State of Utah
DEPARTMENT OF NATURAL RESOURCES
DIVISION OF OIL, GAS AND MINING

Re: Adjustment of Permit Boundary and Identification of Areas to be Reclaimed as Resolution of Noncompliance, Absolute Mining and Minerals, Inc. (AMMI), Dolores River Placer Operation, S/019/035 (UTU-72488), Grand County, Utah

5.99
Acres
POST#6
AM3
POST#1
POST#7
POST#5
POST#2
0.83
Acres
AM4
4.15
Acres
AM4
POST#3
POST#4
0.92
Acres
0.71
Acres
AC2
1993 Digital Orthophoto Quad
Dolores River Placer Mine S/019/035
N
W
E
S
100 0 100 200 Feet

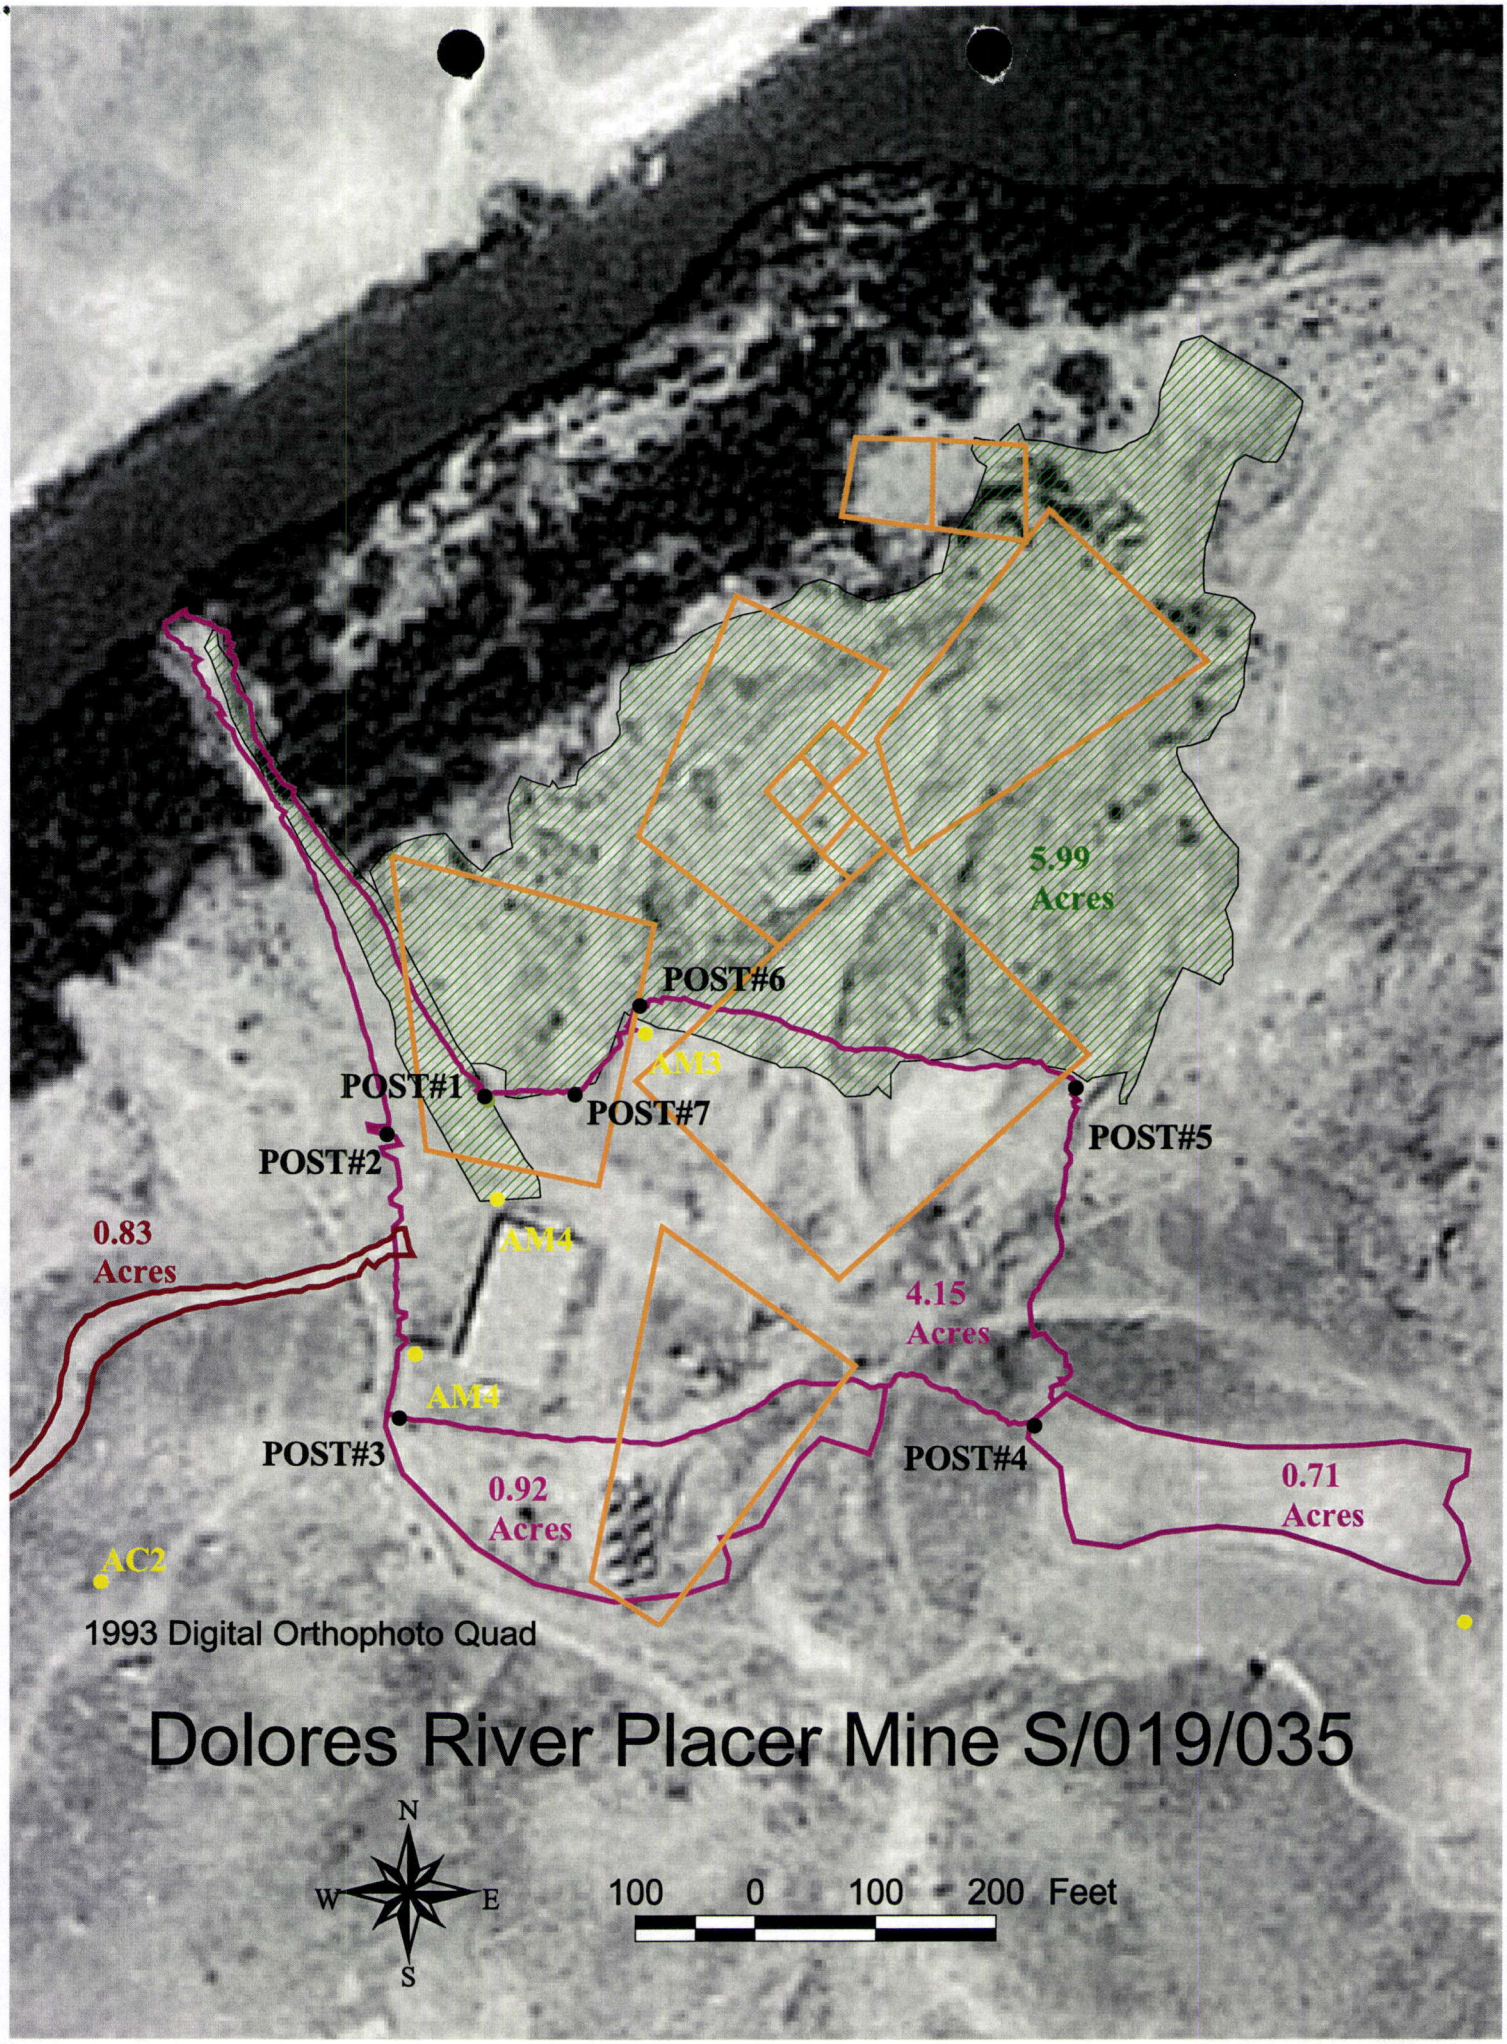
The revised surface map prepared by the Division uses seven posts to identify key corner points of the new permit boundary as proposed by AMMI. Six of these posts are metal stakes driven into the ground as semi-permanent markers. GPS coordinates for these metal posts were recorded to allow relocation of their positions if they become disturbed. The new permit boundary is marked by these posts and the regions discussed during the March 20, 2001, site inspection. The new permit boundary includes the pipeline access corridor from the building to the pump on the bank of the Dolores River.

This new permit boundary encompasses approximately 4.15 acres. The access road from the new permit boundary to the locked gate was measured separately and encompasses approximately 0.83 acres of disturbance. The total acreage for the revised permit boundary including the road is approximately 4.98 acres. This will be considered the total amount of disturbance for this small mine operation until the reclamation responsibility for the access road changes.

PAD AREA - The pad area south and east of the new permit boundary shown on the map between Post #3 and Post #4 was excluded from the new permit boundary and will need to be reclaimed. Reclamation of the pad area would consist of removal of all structures, equipment and debris, followed by ripping the compacted pad area with a dozer, and then broadcast seeding the affected area immediately after ripping. The preferred time for seeding, and therefore, the preferred time for completing the earthwork is late fall. This pad area as shown on the new map encompasses approximately 0.92 acres.

HILL AREA – The hill area disturbance outside of the new permit boundary, and located to the south and east of Post #4 on the map, will need to be reclaimed. Reclamation of this area would consist of regrading the material from around the perimeter and from piles, back over the disturbed area, and broadcast seeding the affected area immediately after regarding. Again, the preferred time for seeding is in the fall and while the soils are still loose from any earthwork. The hill area as shown on the new map encompasses approximately 0.71acres.

(1) Accept the new boundary as described by the enclosed map as the permit boundary for active mining operations at the Dolores River Placer Mine,

(2) Complete reclamation of the Pad Area and Hill Area as described above during the fall of 2001, and

(3) Limit active mine operations (other than the above described reclamation) to within the new permit boundary as described by the revised surface map.
